TOLERANCES: STANDARD TOLERANCES MATERIAL: STAINLESS STEEL FINISH:	CONTRACT NO.:			GOMPf BRACKETS, INC.		Email: Sales@Bracket.com		
	APPROVALS:			12426 Mukiteo Speedway Ste C		Mukiteo, WA 98275-5731		Phone: 425-348-5002 Fax: 425-348-5150
	DRAWN BY: PBB / VW	DATE: 3/3/03	DWC. NO. 6089-1440		ROUND HEAD 4-40		REV. 0	
	CHECKED:	SCALE: 5:1		PHILLIPS SCREW

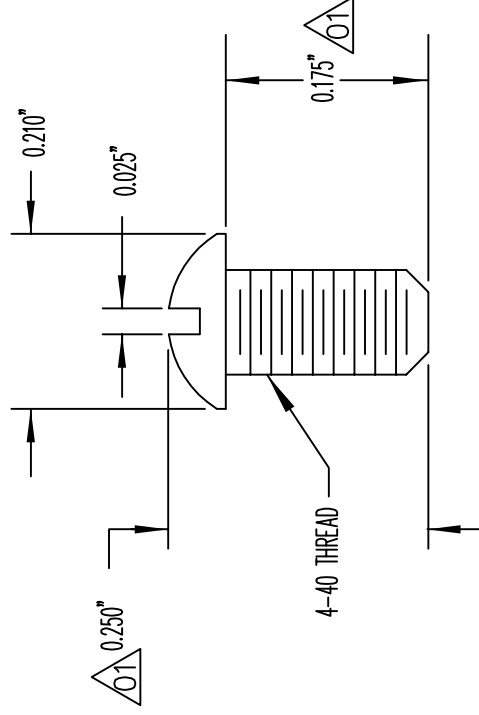
ENGINEERING CHANGE ORDER		DATE
Item#	DESCRIPTION	12/3/91
00	ORIGINAL	
$\triangle 01$	UPDATED DIMENSIONS TO MATCH SCREW, DIM 0.175 WAS 0.123, 0.250 WAS 0.188	3/3/03
